Change No. 15
License No. DPR-28

SAFETY EVALUATION BY THE DIRECTORATE OF LICENSING

VERMONT YANKEE NUCLEAR POWER CORPORATION

CHANGE NO. 15 TO TECHNICAL SPECIFICATIONS

Figure 3.5.1.A Maximum Allowable Planar LHGR

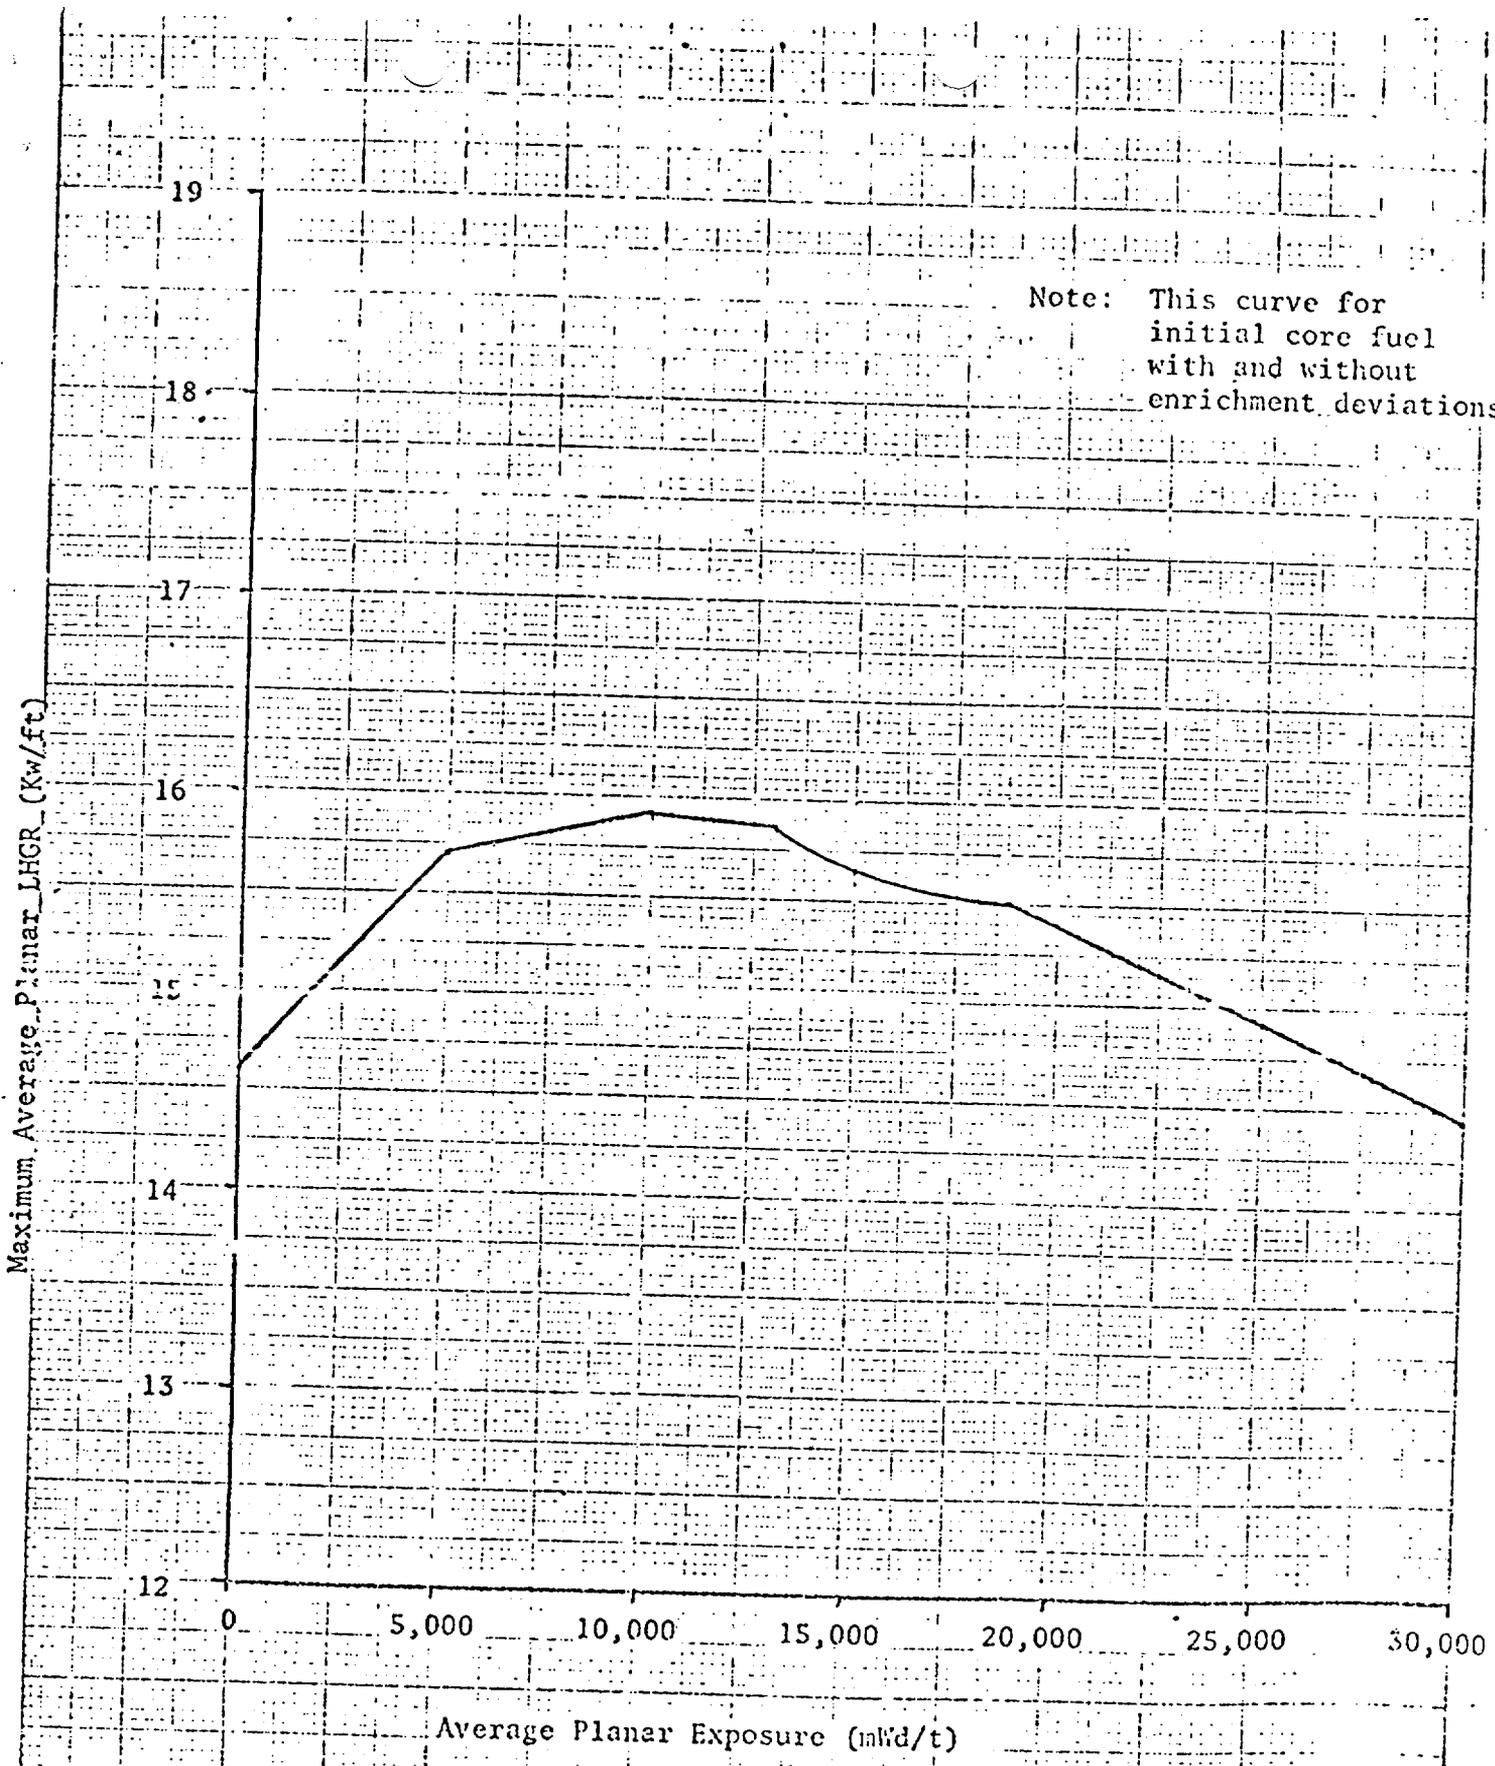
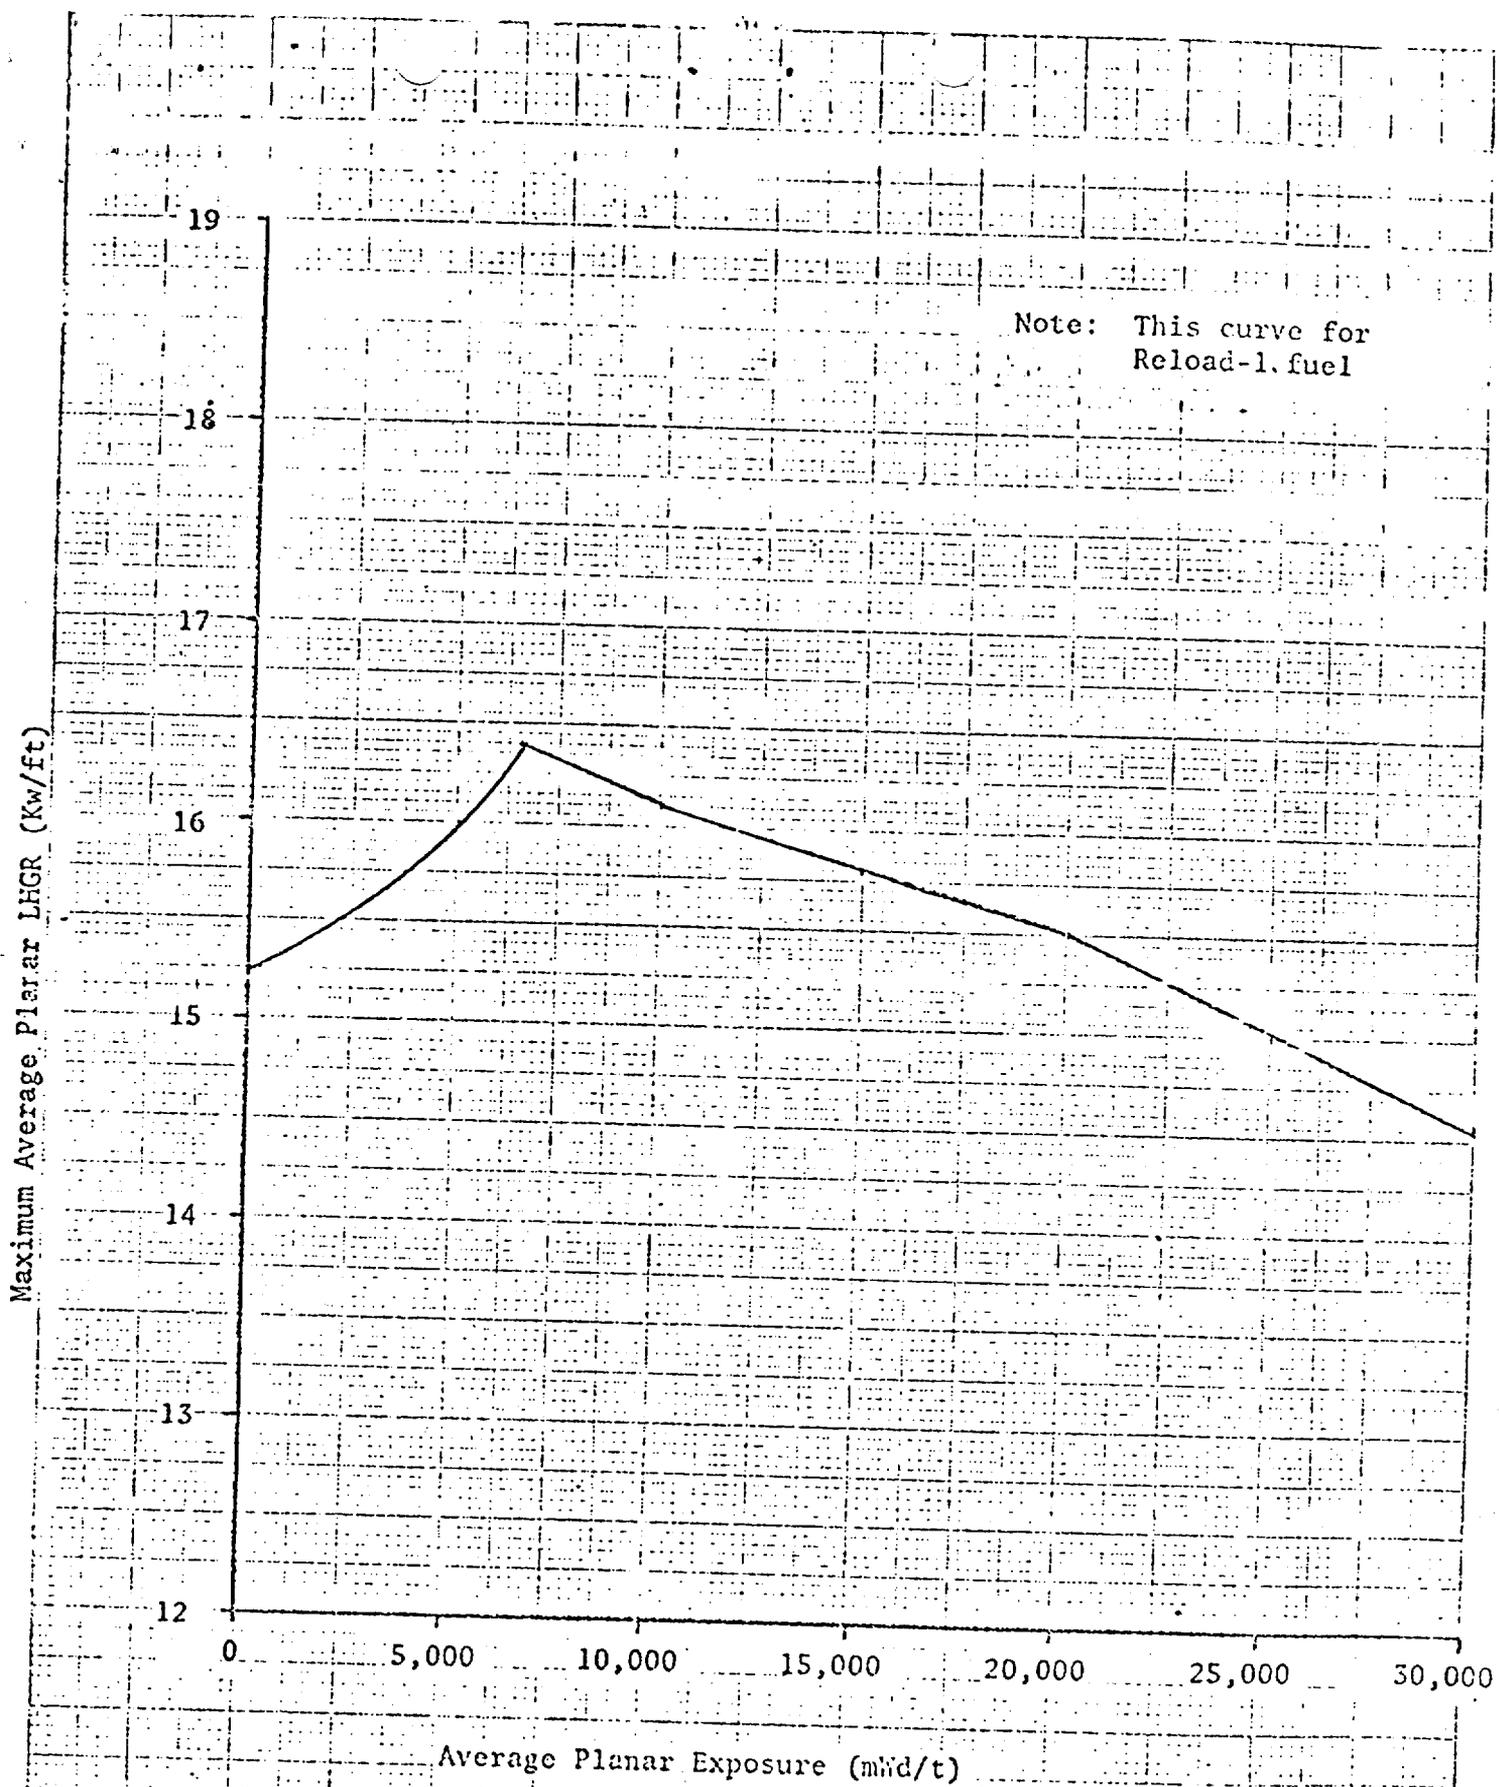
The maximum average planar LHGR shown in Figures 3.5.1.A and 3.5.1.B is the same as that shown on the curve labeled " Ω " (Omega) on Figures 1-G and 2-G in the General Electric letter of J. A. Hinds to V. A. Moore, "Plant Evaluations with GEGAP-III," dated December 12, 1973, based on calculations employing the models described in the General Electric reports NEDM-10735 as modified by the General Electric report NEDO-20181 and the aforementioned General Electric letter of December 12, 1973.

Figure 3.6.1 Minimum Reactor Pressurization Temperature

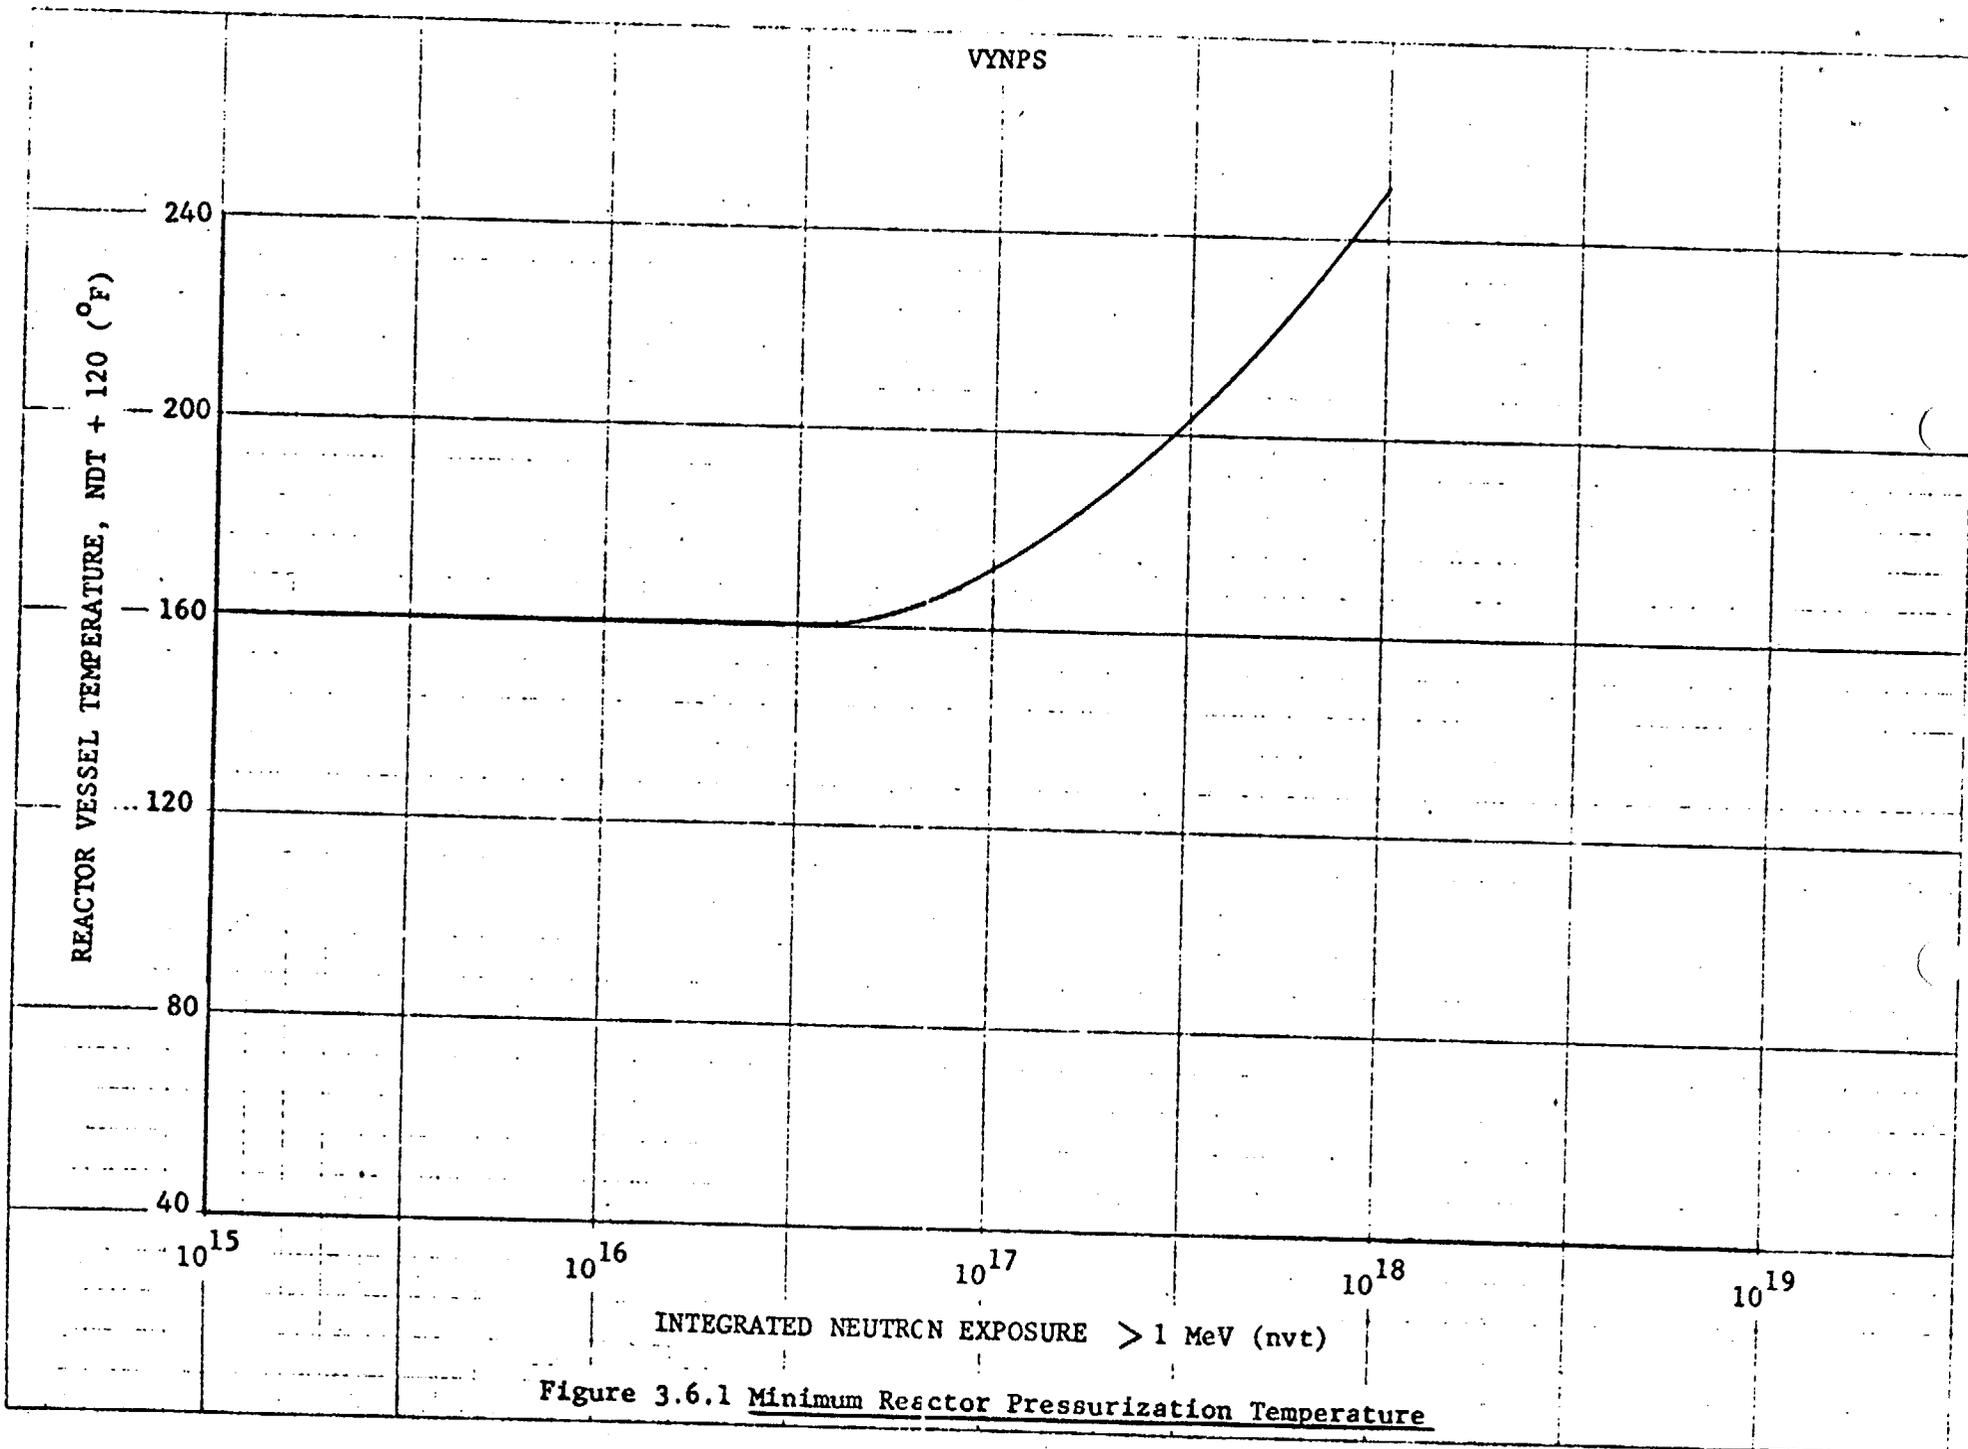
The "worst case" curve relating change in transition temperature to neutron fluence as presented in the FSAR was used to construct the "Minimum Reactor Pressurization Temperature" curve of Figure 3.6.1. This curve is based on an initial NDT of the vessel shell adjacent to the core. A 60°F margin based on the requirements of Section III of the ASME Boiler and Pressure Vessel Code, and a 60°F margin to account for the thickness effect of heavy section steel were added to 40°F to give the 160°F minimum temperature from initial operation to the time when the neutron fluence exceeds 5×10^{16} nvt. At that time the minimum temperature will increase steadily as the neutron fluence increases based on the "worst case" curve. After 40 years of operation the minimum operating temperature will be about 180°F.
